M-1977-410 AM2 Adequacy Review Response #3

RE: Cross Gold Mine, Permit No. M-1977-410, 110(2) Hard Rock Permit Amendment Application (AM-02), Adequacy Review No. 3

Grand Island Resources Cross Mine (M1977-410) Amendment #2 Response to DRMS Comments Dated December 29, 2021

EXHIBIT E: CROSS AND CARIBOU MINES MINING PLAN MAP PROPOSED INTERNAL ROAD

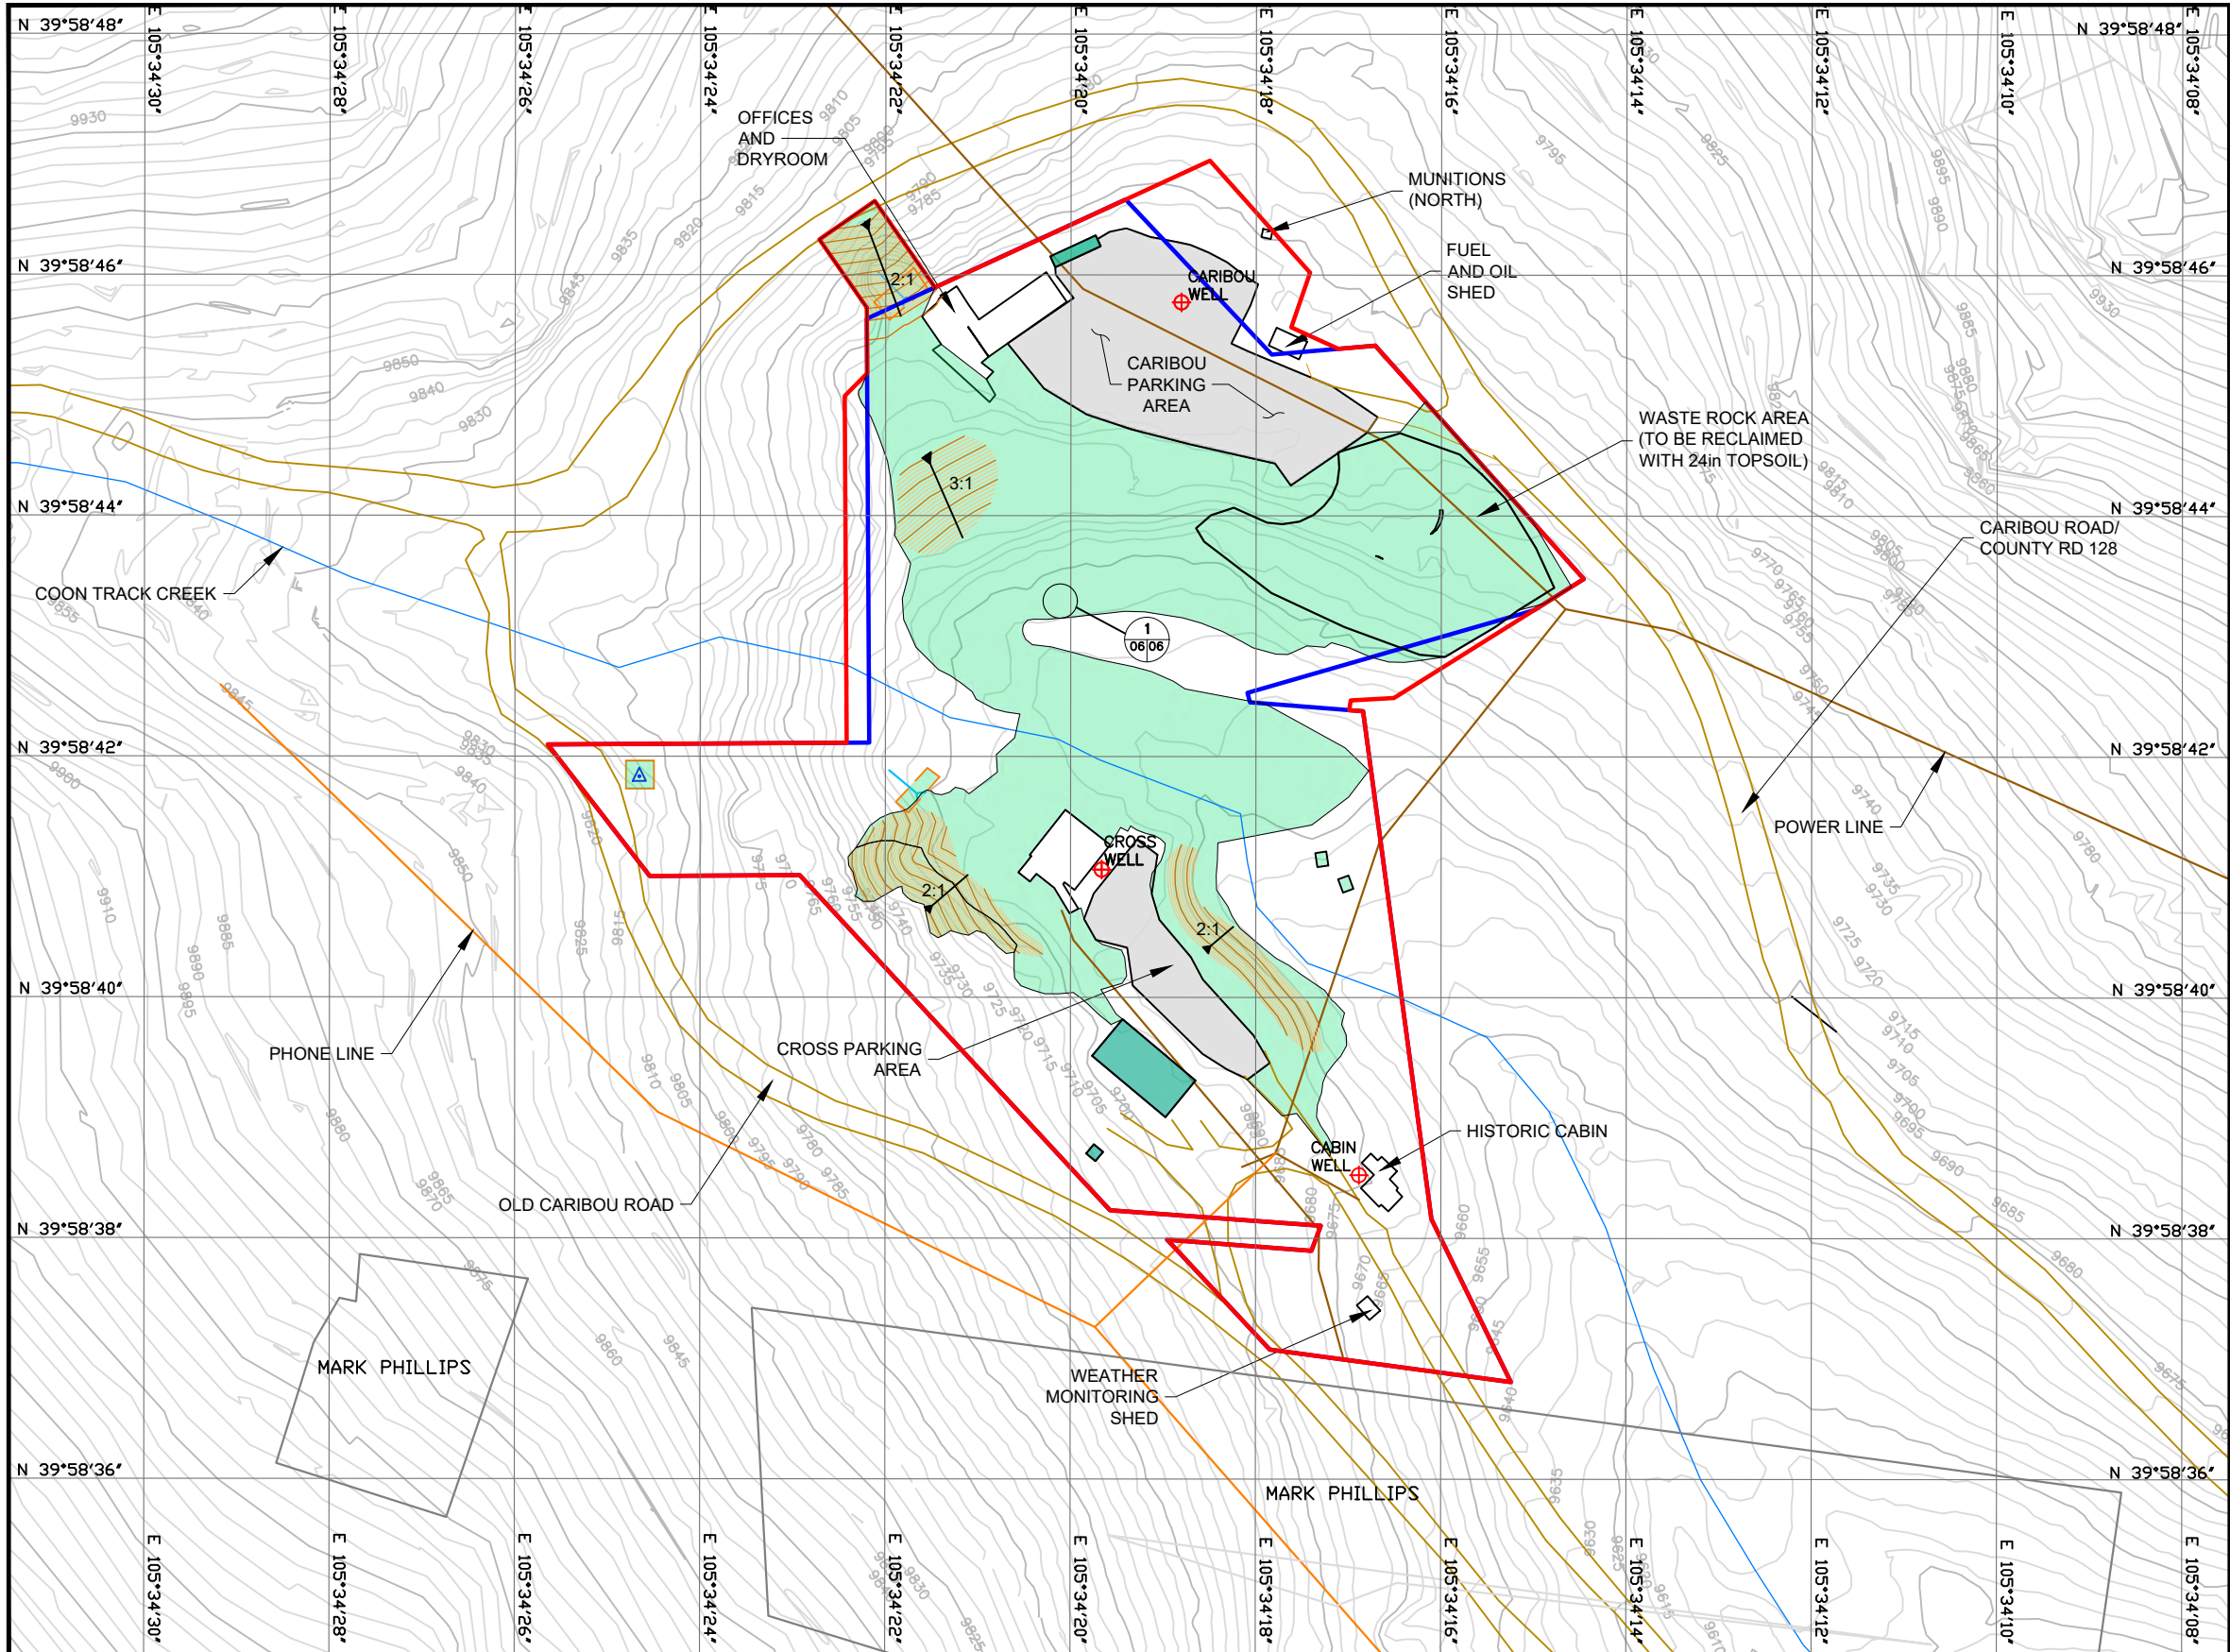
- a. Please add “Exhibit E” and “Mining Plan Map” to the map title.
- b. The “Current Permit Boundary” indicated on the map (with a blue line) and stated in the legend to be 9.36 acres, is not accurate. The current permit area is 8.95 acres, as of the Division’s approval of Acreage Reduction No. 1 on November 12, 2020. Please correct this boundary on the map and correct the acreage in the legend.

- c. Please remove the “Ore Storage Area” shown in the Cross Mine area, as the Division does not authorize the operation to continue storing ore at this location (as described above).

- d. Please label the CDPHE discharge point.
- e. Please label the explosives storage area.
- f. Please show all water infrastructure, including pipelines (infrastructure specifically related to the new water treatment system should be submitted in the Board-Ordered Technical Revision and not in this application). How will water from the Cross and Caribou mines be directed to Pond 2 with the proposed new internal road to be constructed between these features?

- g. Please show the approximate location(s) for the box culverts to be installed beneath the proposed new internal road.
- h. This map shows the proposed new internal road covering the Munitions (South) structure. Will this structure be removed prior to construction of the road? (According to Map 6, the area where this structure is located will be reclaimed.)

*The Cross Ventilation Shaft was removed because it does not exist.
Please see revised Map 2 in Exhibit E.*

EXHIBIT E - CROSS AND CARIBOU MINES RECLAMATION PLAN MAP CROSS/CARIBOU

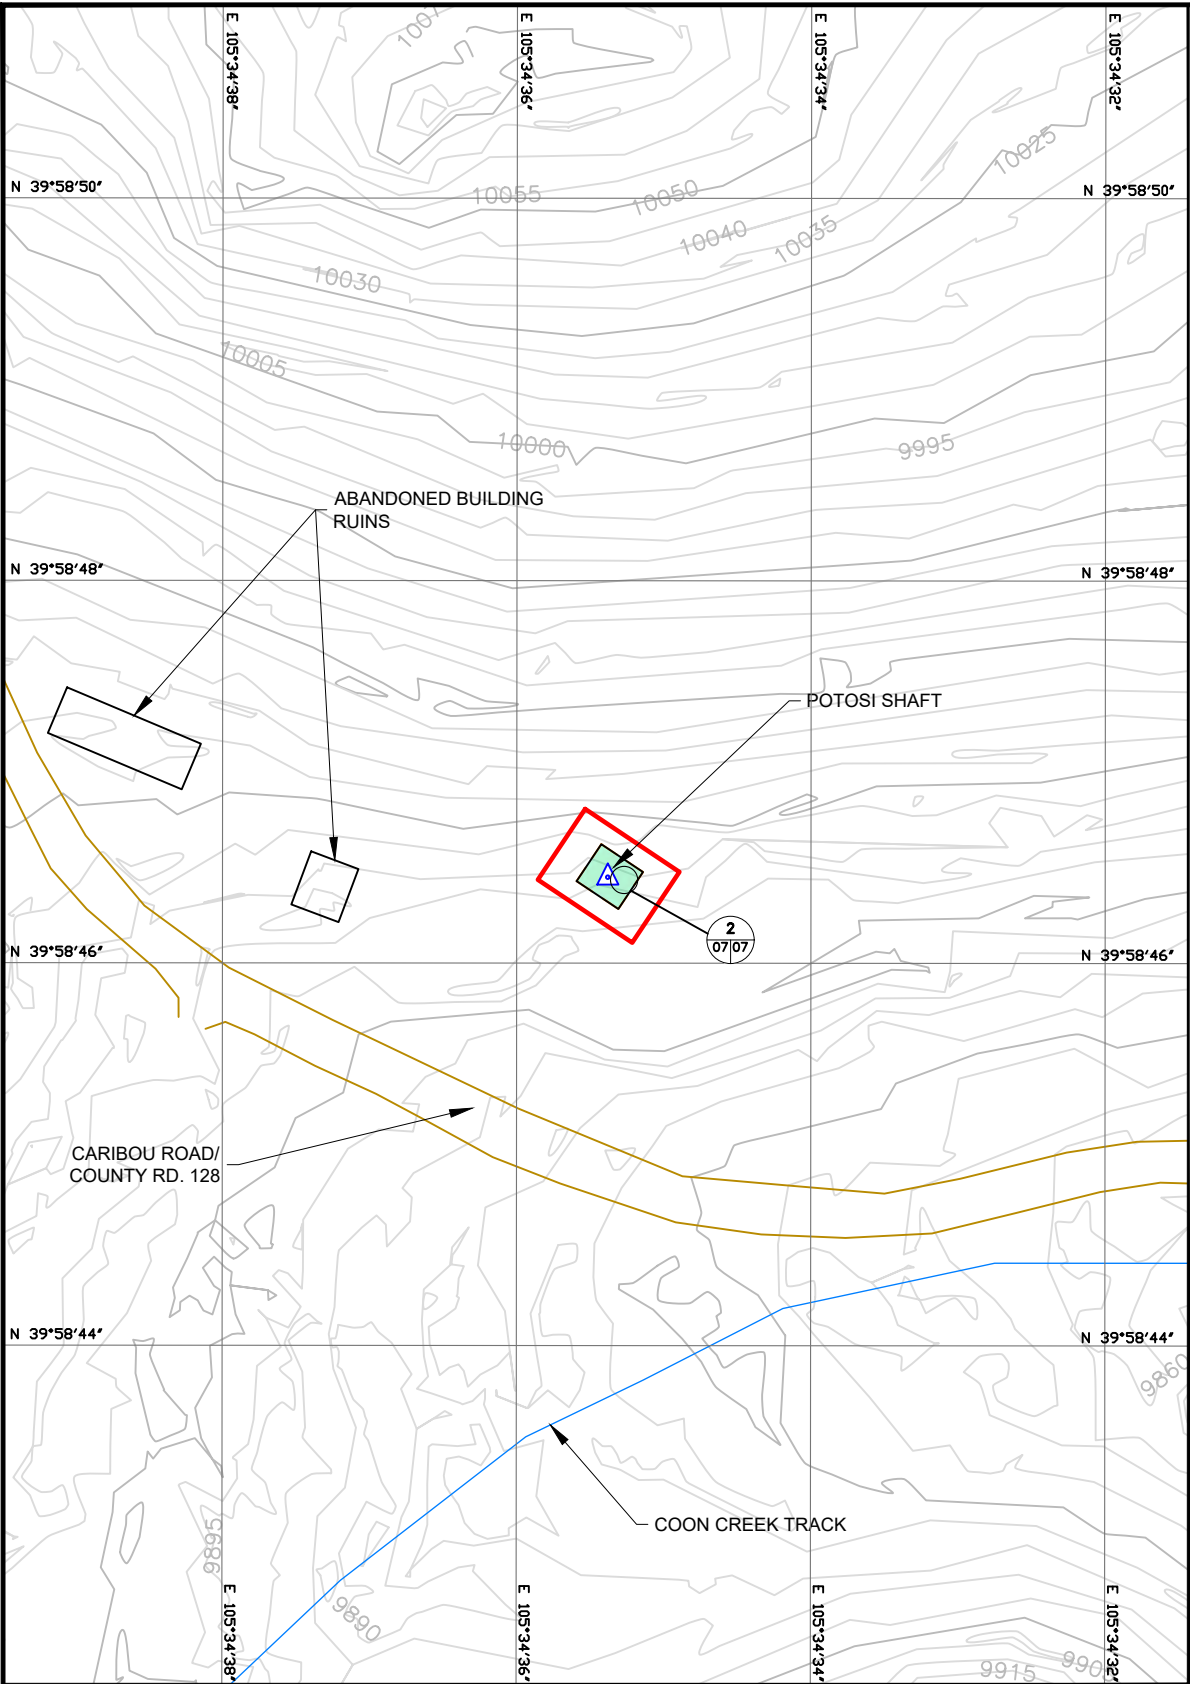
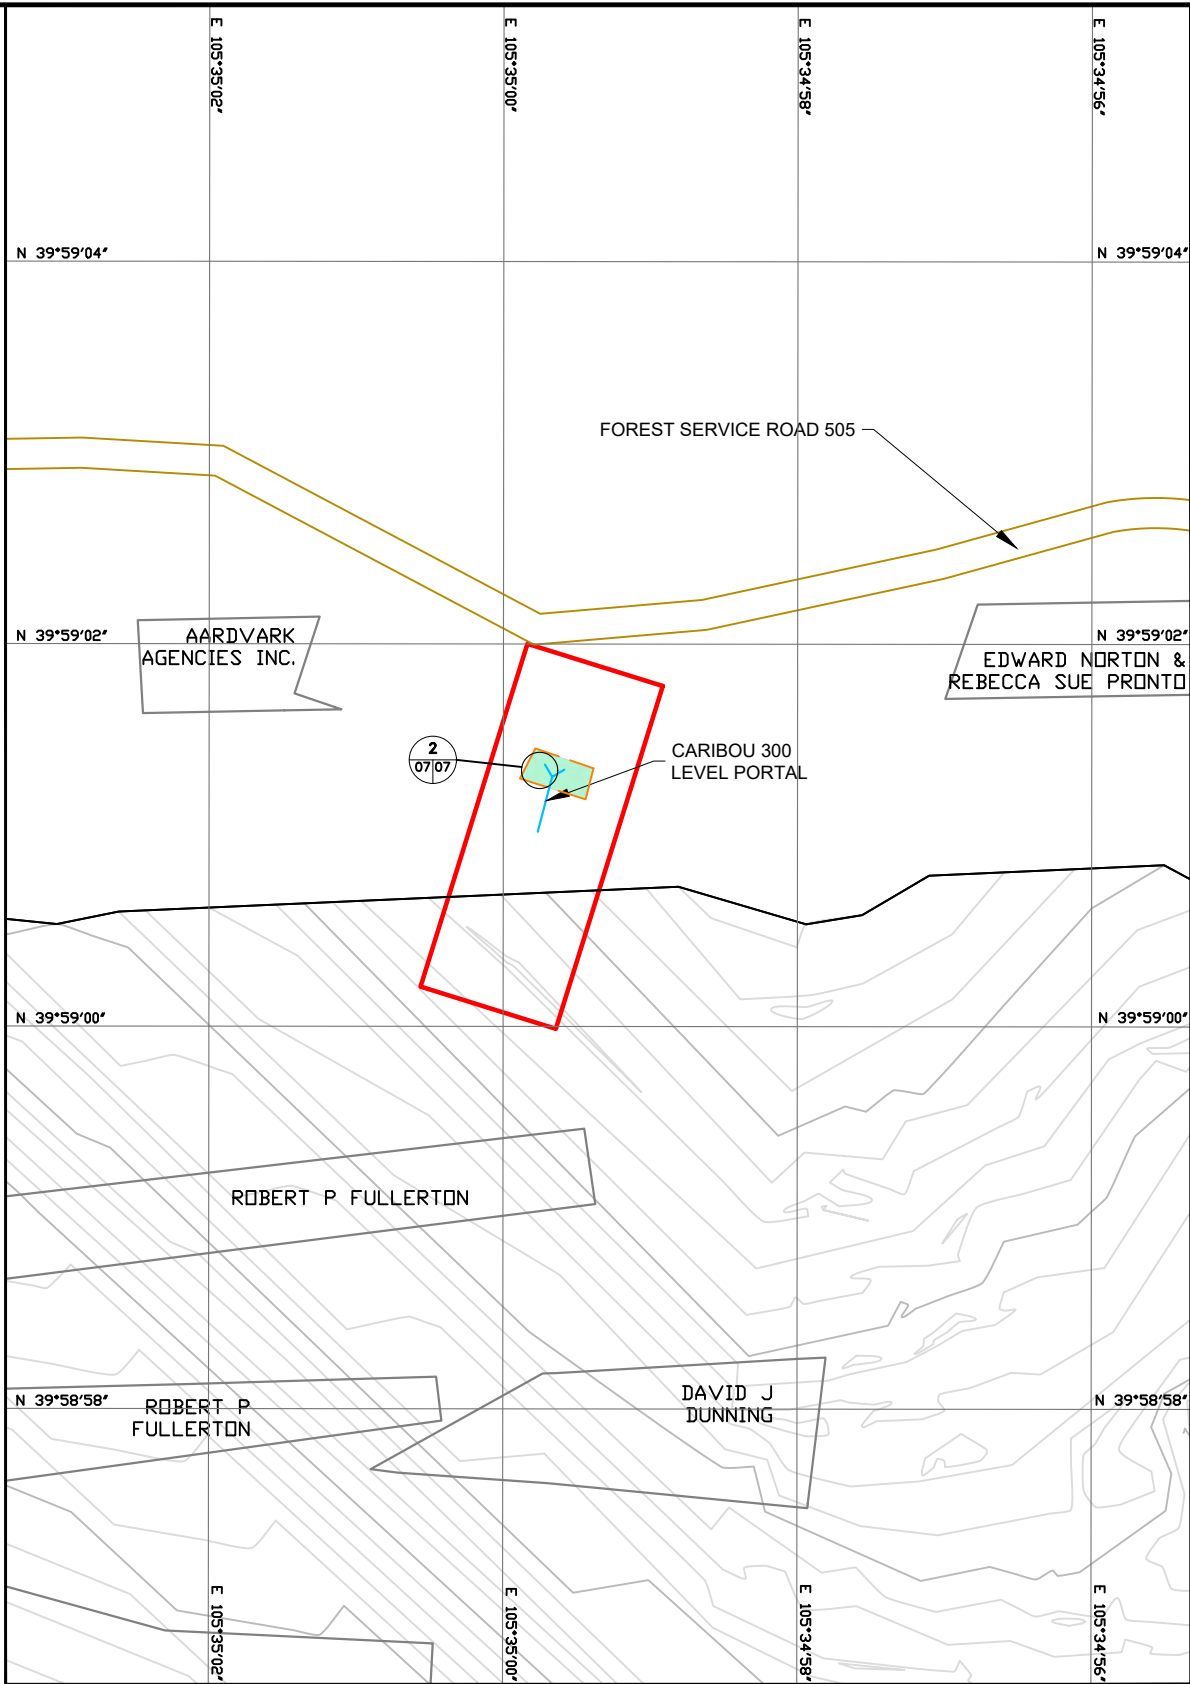
- a. Please add “Exhibit E” to the map title.
- b. The “Current Permit Boundary” indicated on the map (with a blue line) and stated in the legend to be 9.36 acres, is not accurate. The current permit area is 8.95 acres, as of the Division’s approval of Acreage Reduction No. 1 on November 12, 2020. Please correct this boundary on the map and correct the acreage in the legend.
- c. In the “Typical Top Soil Cover Detail, it shows that 24 inches of topsoil will be placed on reclaimed areas. However, the proposed reclamation plan indicates that 8-12 inches will be placed on the majority of the disturbed land, with 24 inches to be placed only on the waste rock storage area. If 24 inches of

topsoil will be replaced on all disturbed lands, please be sure the reclamation plan and bond estimate are updated accordingly. Otherwise, please revise the Typical Top Soil Cover Detail on this map to reflect the actual proposed topsoil replacement depth for most disturbed areas.

d. Please remove the Cross Snowshed, since the proposed reclamation plan includes removing this structure.

e. The proposed reclamation plan includes three different seed mixes for the site (Tables 3-5). Please show the approximate locations on this map that will receive each of the proposed seed mixes.

f. If Map 5 is removed, as recommended above, please be sure to add the proposed slope gradients to this map.

c. Please see renumbered Map 5 and revised text
